POOL PROJECT FOR THE AMERICAN EMBASSY ANNEX, ABIDJAN- CÔTE D'IVOIRE

PROJECT OWNER: UNITED STATES EMBASSY

DETAILED PLANS

WORK MASTER	
USA EMBASSY	**BUILDING PORCH FOUNDATION FORM WORK**

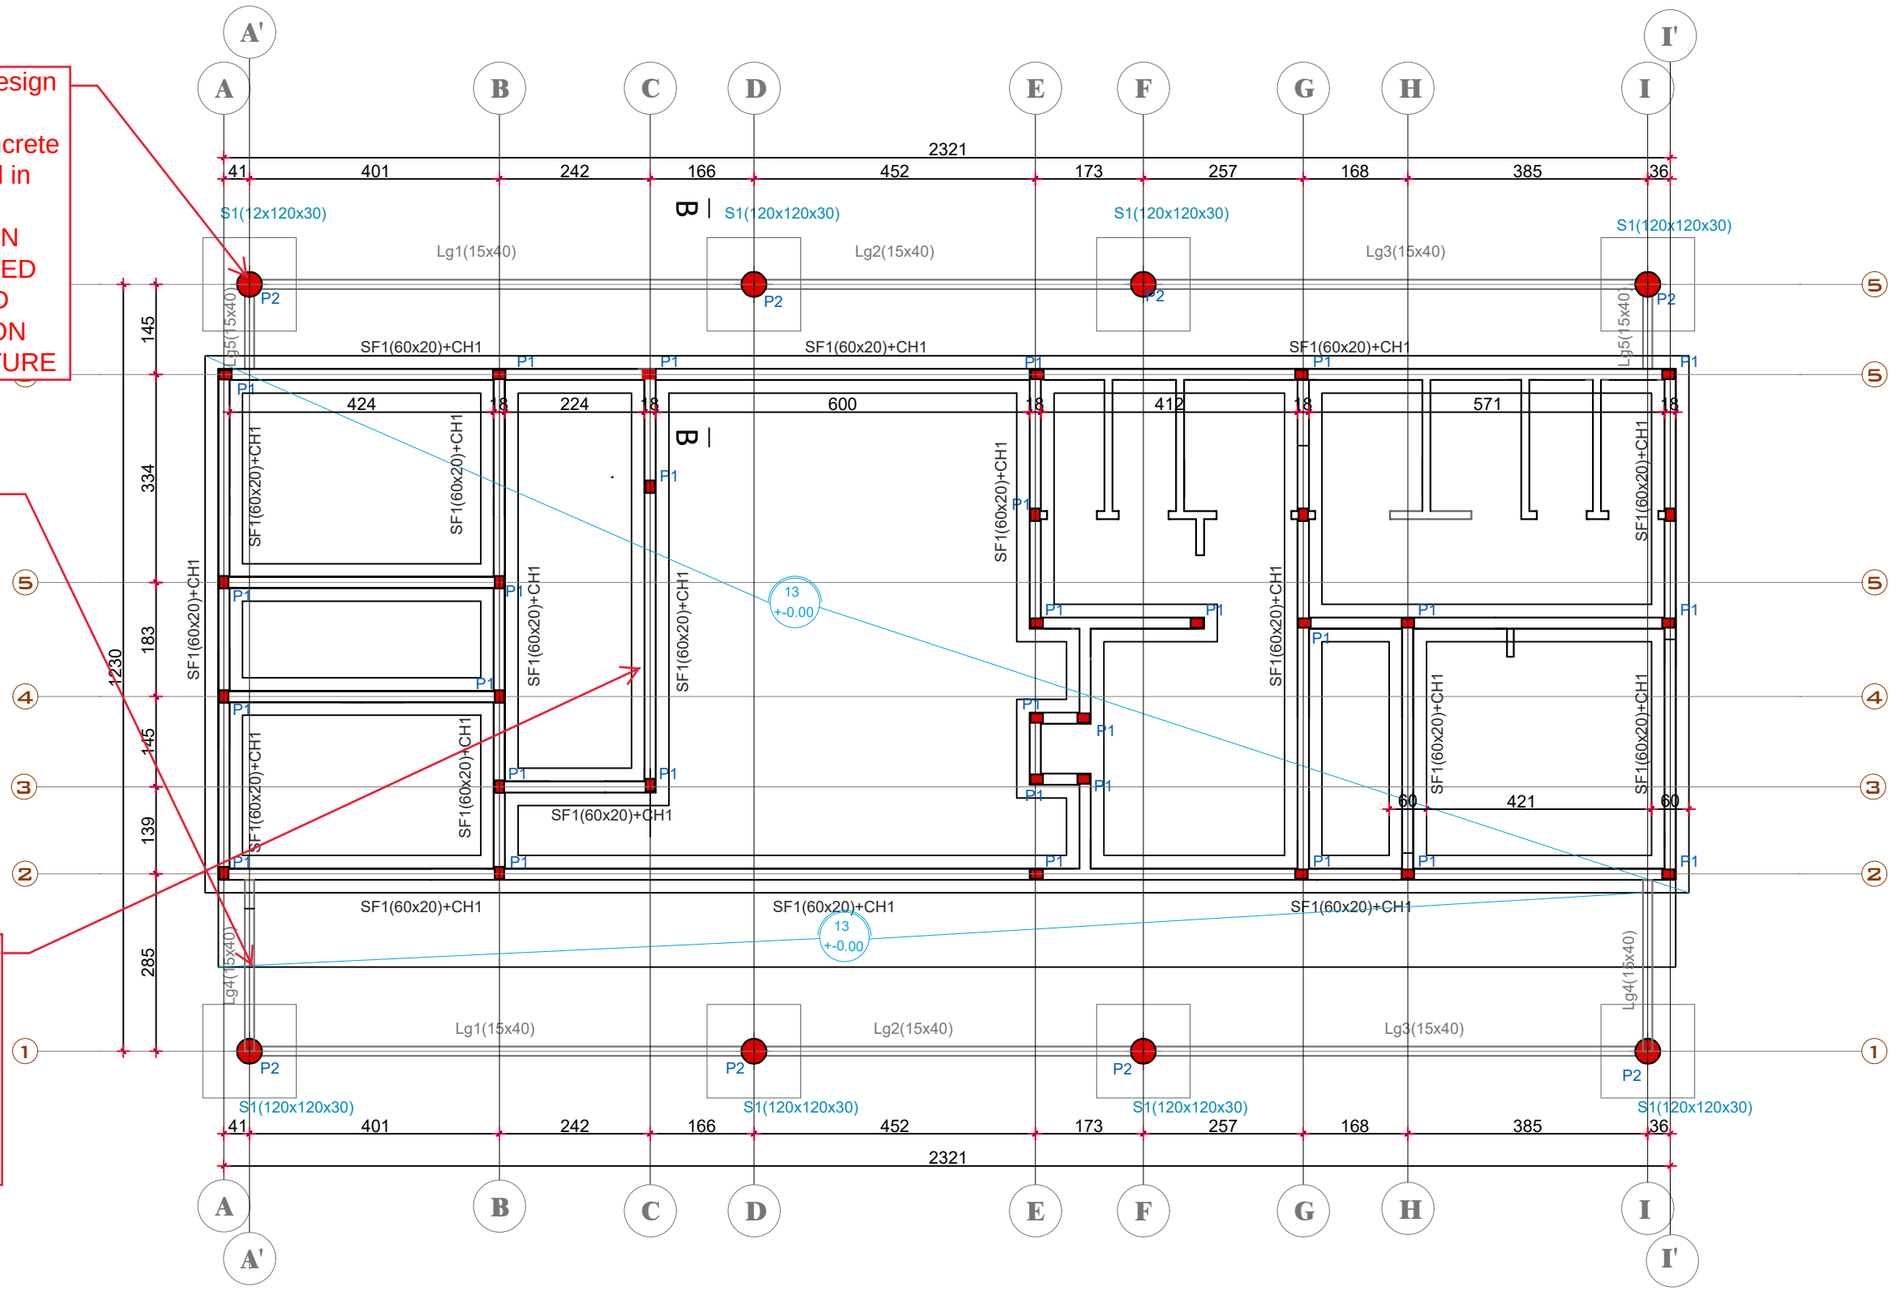
Refer to the design notes of the reinforced concrete structure. Find in attached pdf CALCULATION NOTE RELATED TO THE WIND PRESSURE ON THE STRUCTURE

it is about the omissions. we have rectified

the openings on the plans are omissions. the plans have been updated. These have no impact on the structural calculations

BUILDING PORCH FOUNDATION FORM WORK DETAILS

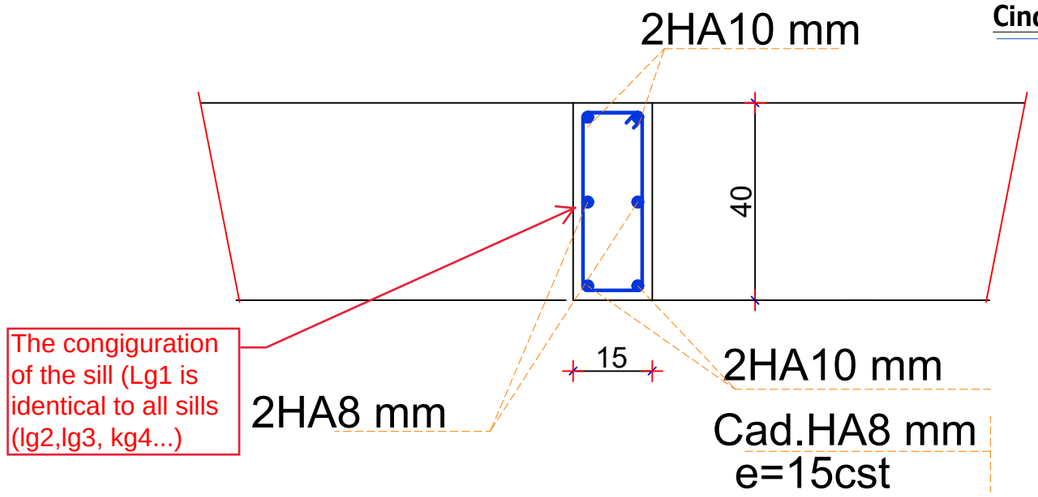
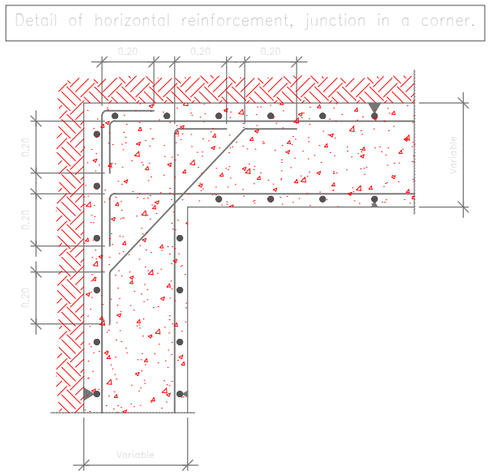
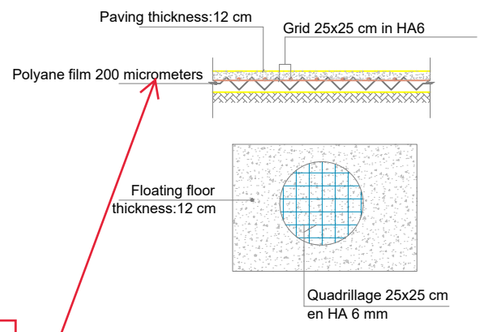
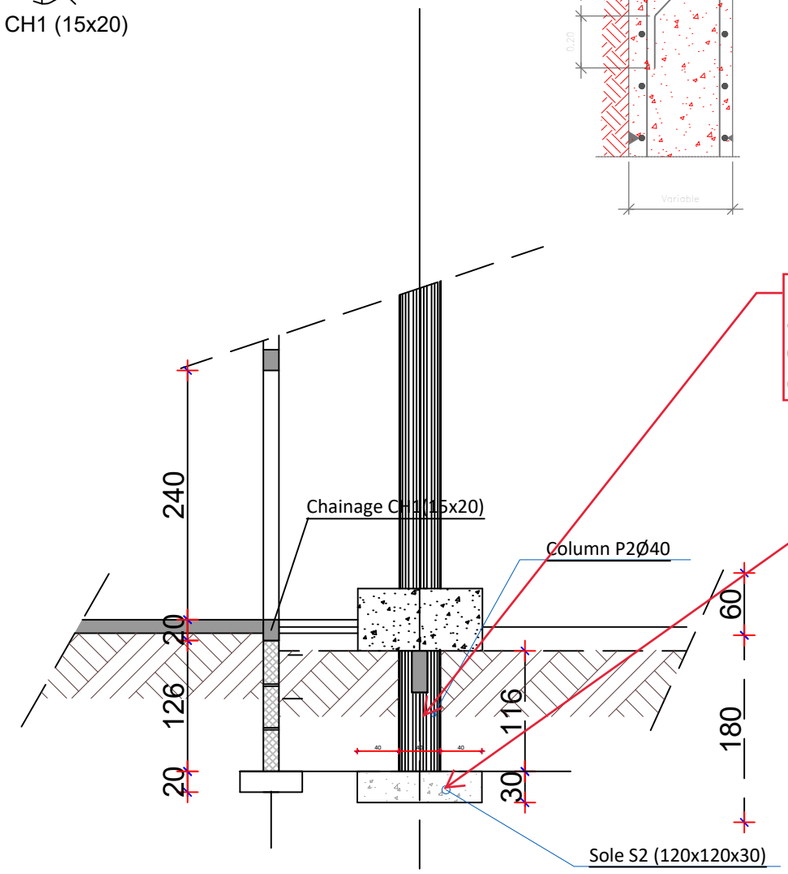
The congiguration of the sill (Lg1 is identical to all sills (lg2,lg3, kg4...)

Above the lintels, we have cinder blocks. The cinder blocks are not reinforced

The thickness of the film is 200 micrometers

refer to the attached pdf: details sole and column
